# Self-Schedules Bid Cost Recovery Allocation and Lower Bid Floor Draft Final Proposal

Comments by Department of Market Monitoring  
August 23, 2016

**Figure 1. Real-time economic bids by bid range and resource type (2015)**

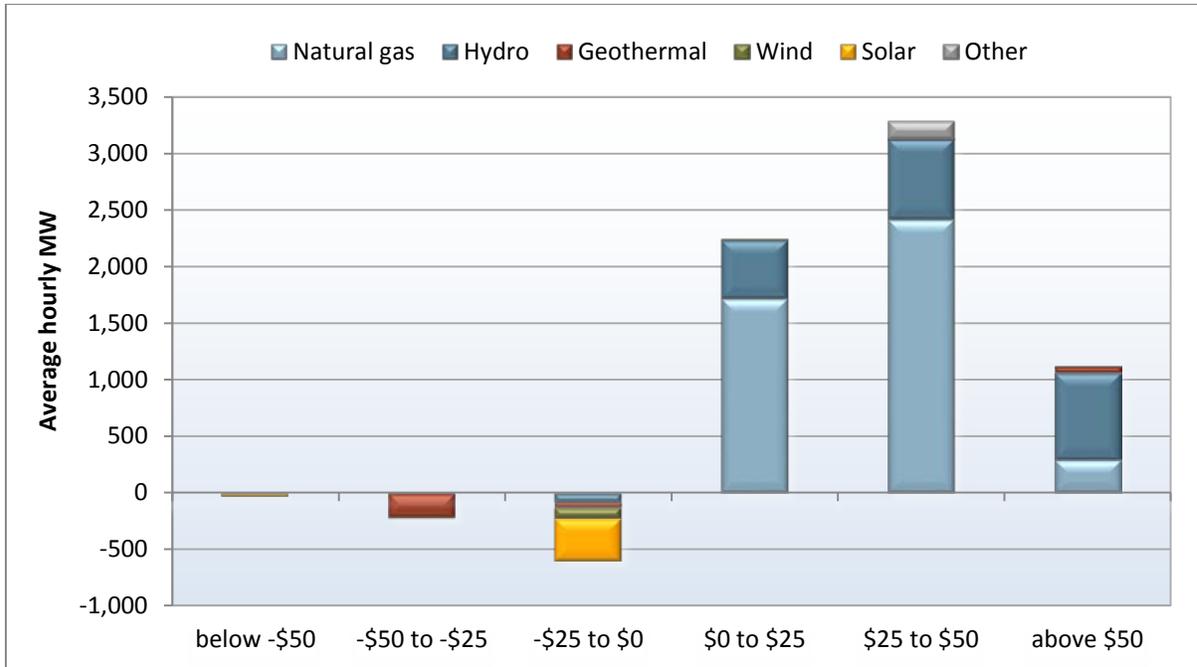
DMM believes that bid data summarized in DMM's 2015 Annual Report, as well as stakeholder comments and the current value of renewable energy tax credits, provide strong evidence that the true marginal cost (or opportunity cost) of most or all resources is higher than the current -\$150/MWh bid floor. Figure 1 shows the ranges of bids submitted to the market by resource type in 2015.

Thus, DMM believes that the data in Figure 1 provides no indication that the current -\$150/MWh is limiting the amount of bids submitted in the real-time market. This conclusion is further supported by the comments of the state’s major load-serving entities – which are parties to most of the PPAs for VERs.

**Figure 2. Frequency of negative 5-minute prices by month (ISO LAP areas)**

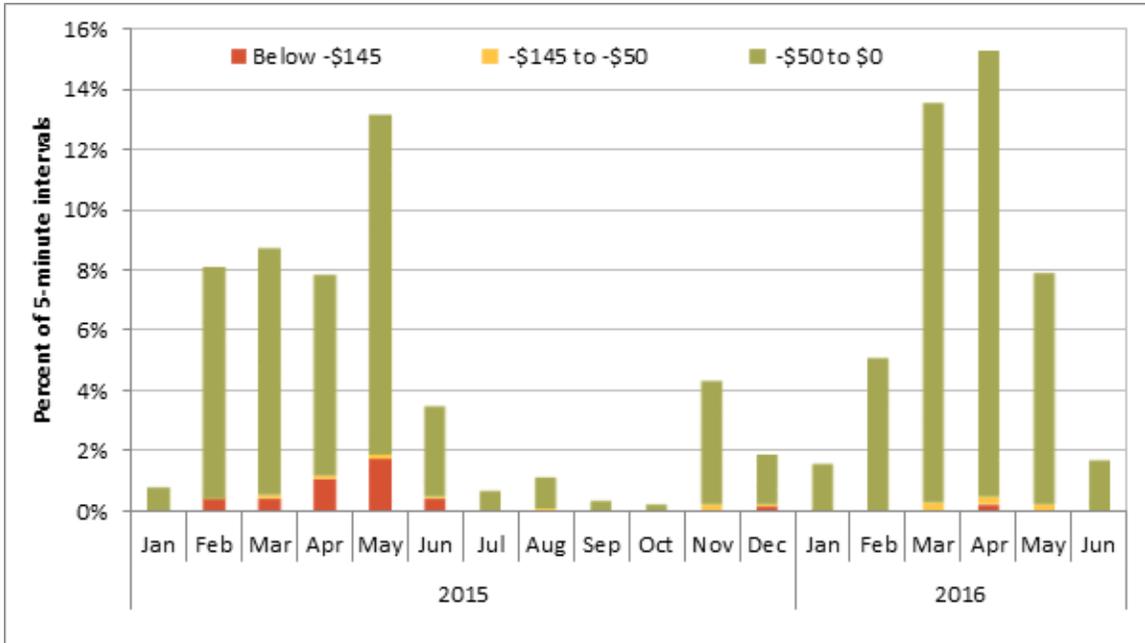
As shown in Figure 2, despite a significant increase in hydro and renewable energy, the frequency of prices roughly at or below the -\$150/MWh bid floor dropped to about 0.1 percent of 5-minute intervals in the second quarter of 2016 compared to about 1 percent during the same quarter in 2015. This represents a significant decrease in the 5-minute intervals when the supply of negatively priced real-time bids to decrease generation was fully dispatched and some resources needed to be curtailed.

**Figure 3. Frequency of negative 5-minute prices by hour (April – June 2016)**

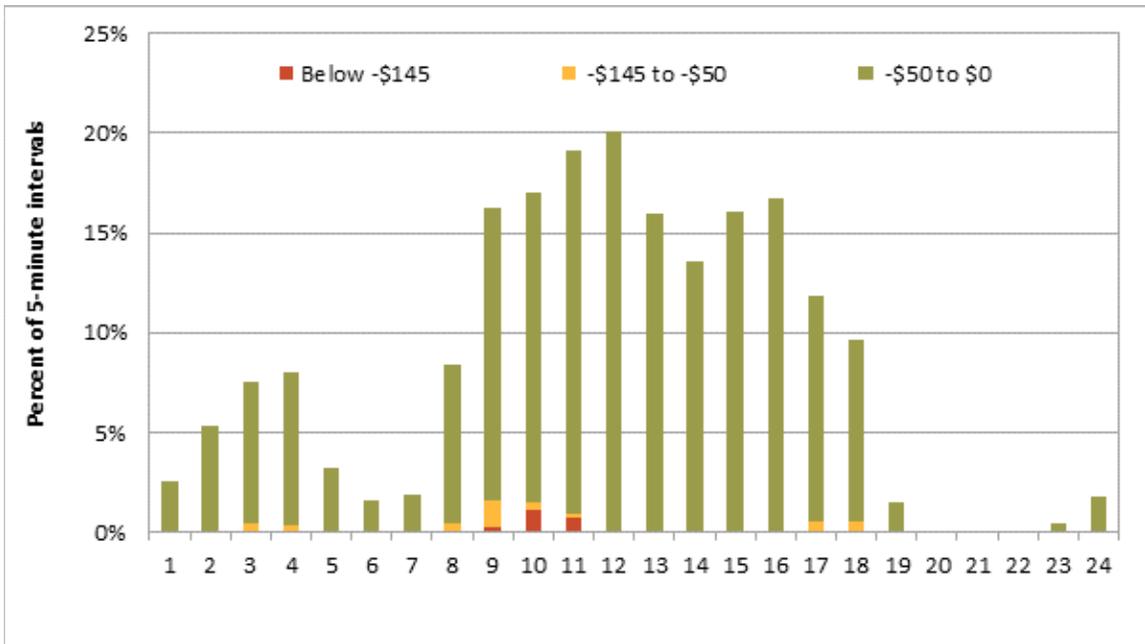
Figure 3 shows the frequency of negative prices in the 5-minute market during the second quarter of 2016 by hour. This figure highlights that the extremely low number of intervals of prices roughly at or below -\$150/MWh occurred during hours ending 10 and 11. These represent hours when solar output is increasing and net load is dropping sharply.

DMM notes that this is one of the key situations that the flexible ramping product being implemented in fall 2016 is designed to address. Once implemented, the flexible ramping product should increase the amount of dispatchable gas-fired generation that can be reduced in the 5-minute market during these hours.
